CWE 2210096.03

**Subject: Response to Third-Party Review Comments (Second Review)
11-Lot Residential Subdivision, 9463 Slope Street, Santee, California**

5) Geotechnical Third-Party Review (Second Review), Slope Street Residential Development (TM2020-01), South of Slope Street at Rhone Road, Santee, California, prepared by Geocon Incorporated, dated August 5, 2022.

PLATE NO.: 1

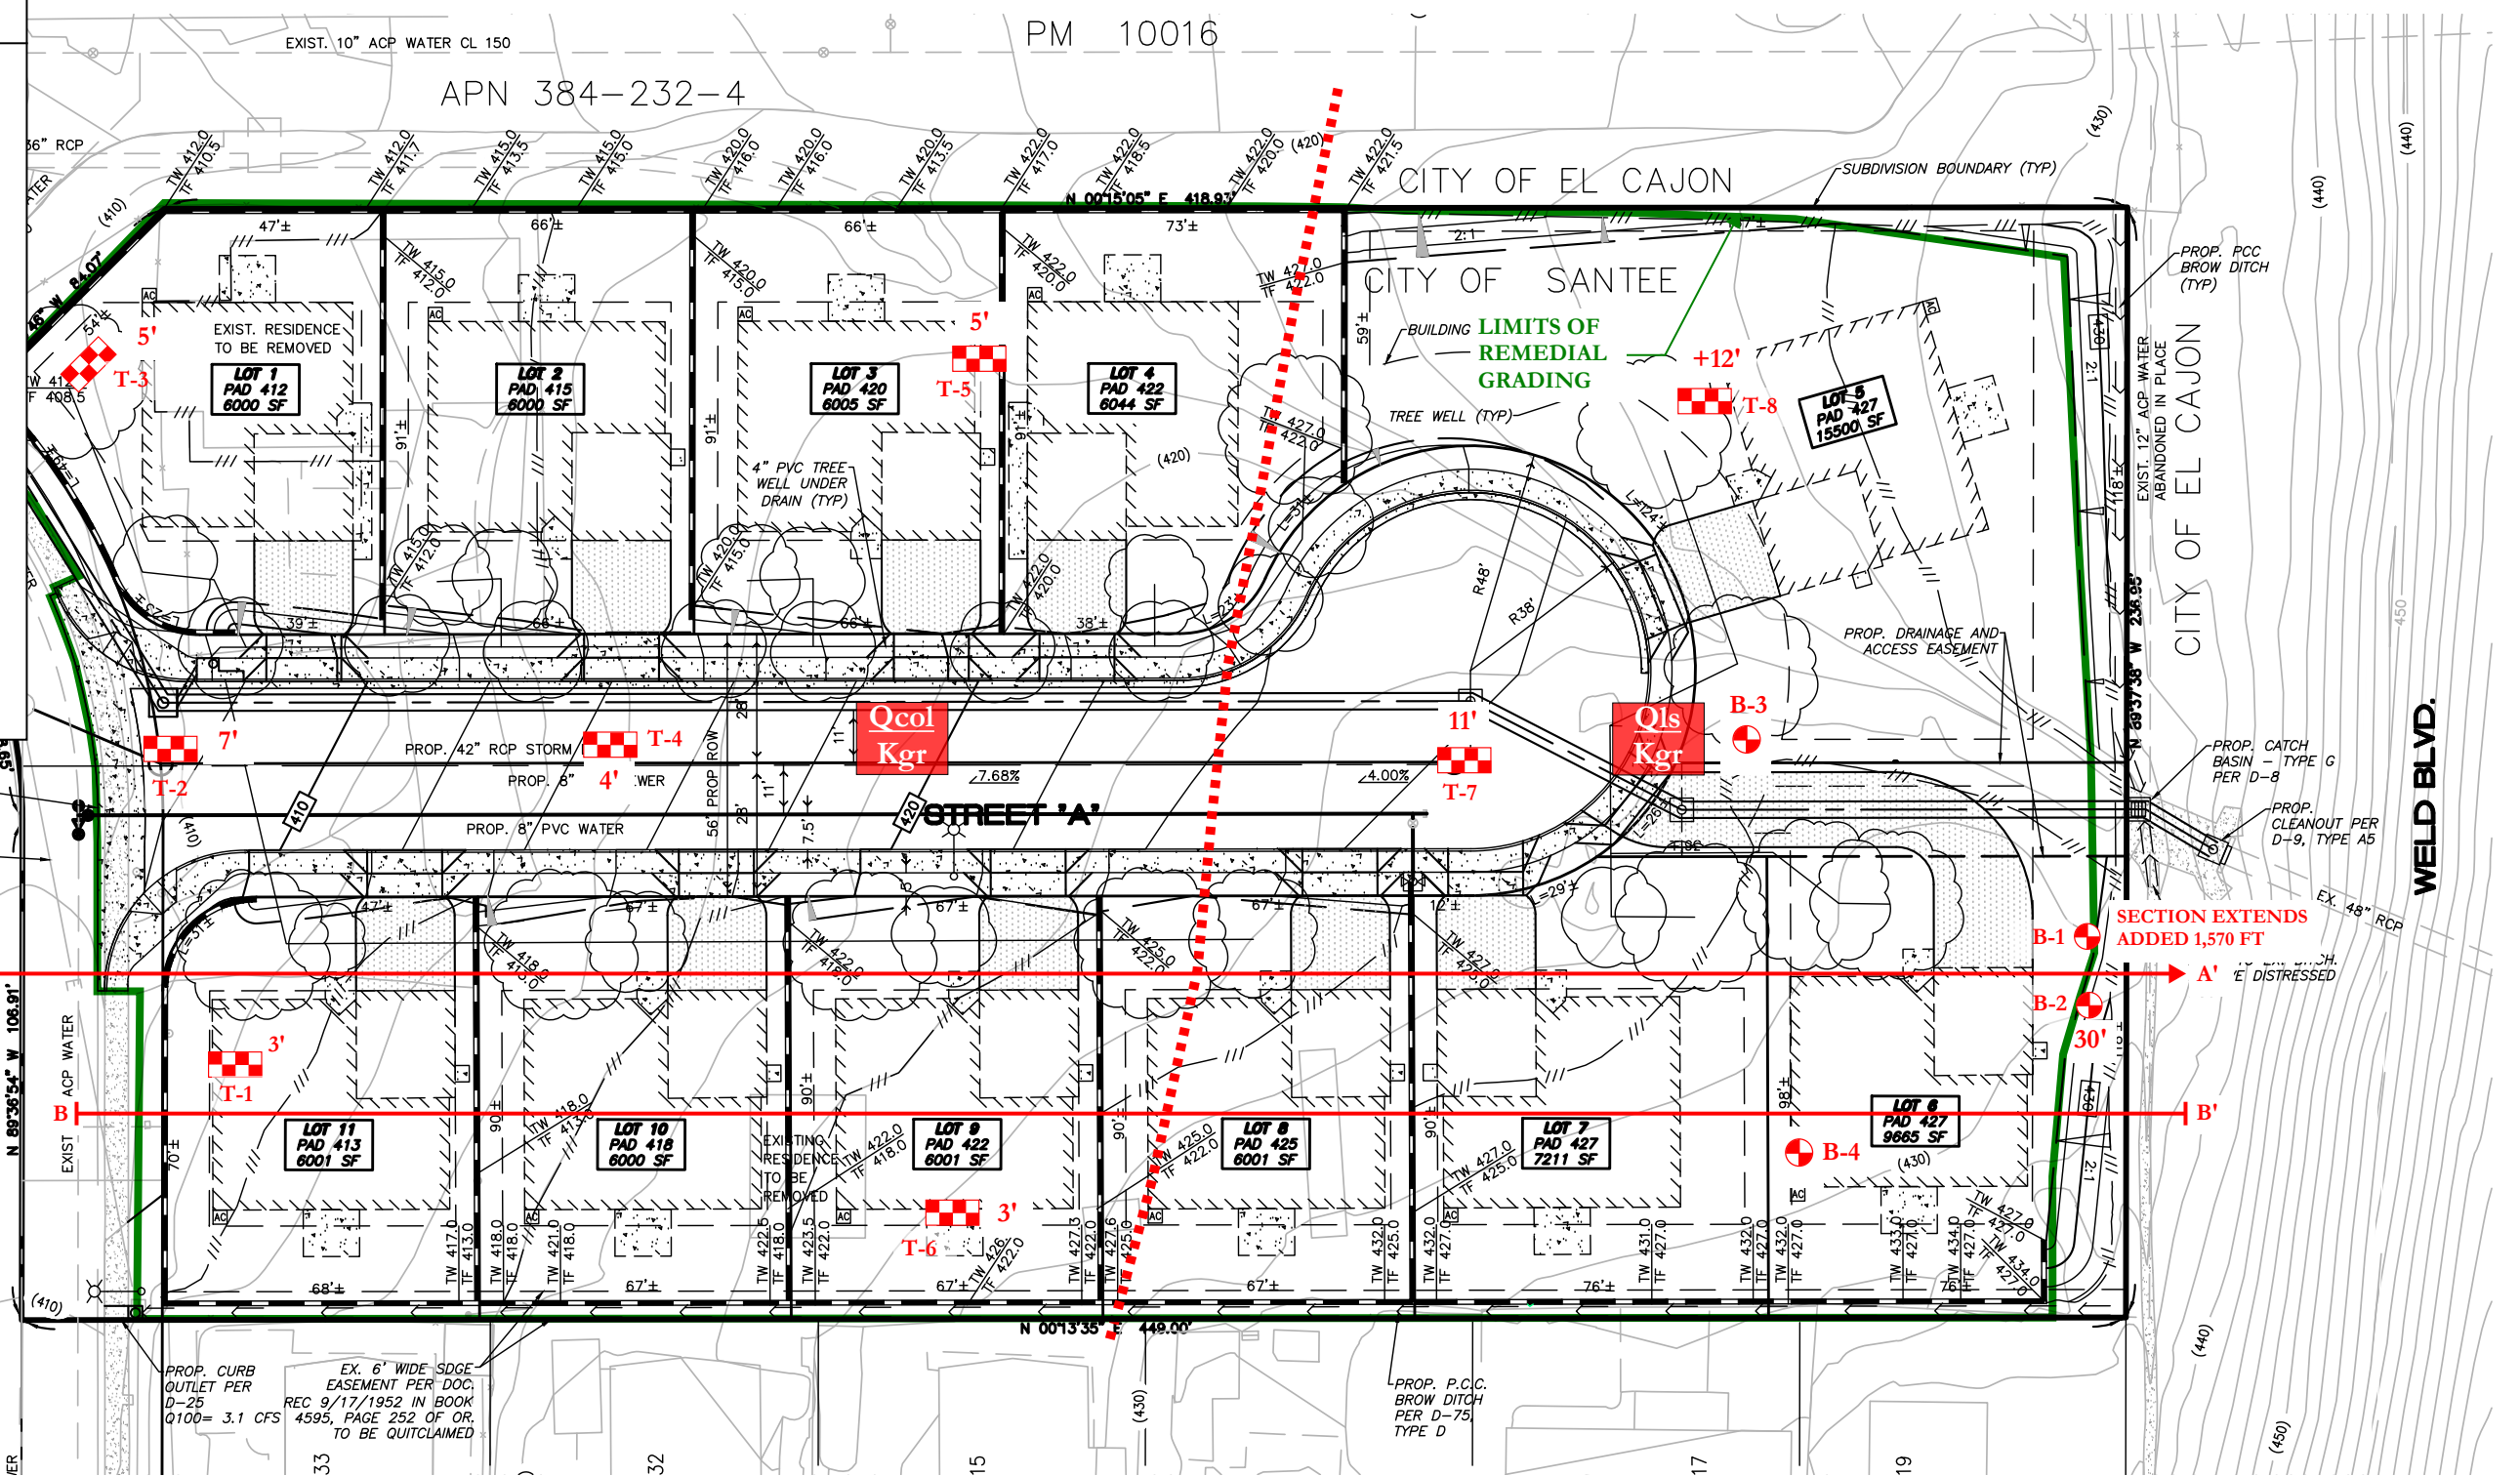
Comment No. 2 Additional Response: The updated slope stability analysis shows a factor of safety of at least 1.5 as required by the City of Santee. However, the shear strength parameters presented in the analysis appear to be based on remolded shears of soil compacted to a dry density of at least 90 percent of the laboratory maximum dry density. The project geotechnical consultant should provide shear tests on the site conditions (i.e. the landslide debris) on relatively undisturbed ring samples, not remolded samples. Please provide updated test results to confirm the shear strengths of the existing and proposed geologic conditions. Additional slope stability analyses may be required based on the results of the laboratory tests.

CWE Response: Two additional borings were drilled within the southern portion of the site in order to collect relatively undisturbed, ring samples of the landslide debris. The locations of those borings are presented on Plate No. 1 of this report and the logs of the additional explorations are presented in Appendix A of this report. Five direct shear tests were performed on representative samples of the landslide debris collected from the recent borings. The testing was performed in accordance with ASTM D3080. The results of these three tests are presented in Appendix B of this report. The results of the direct shear testing indicate that relatively undisturbed samples of the landslide debris demonstrate shear strengths in excess of those modelled in our previous slope stability analyses, which demonstrated a minimum factor-of-safety of 1.5 (CWE, 2022). As such, additional slope stability analyses are not considered warranted.
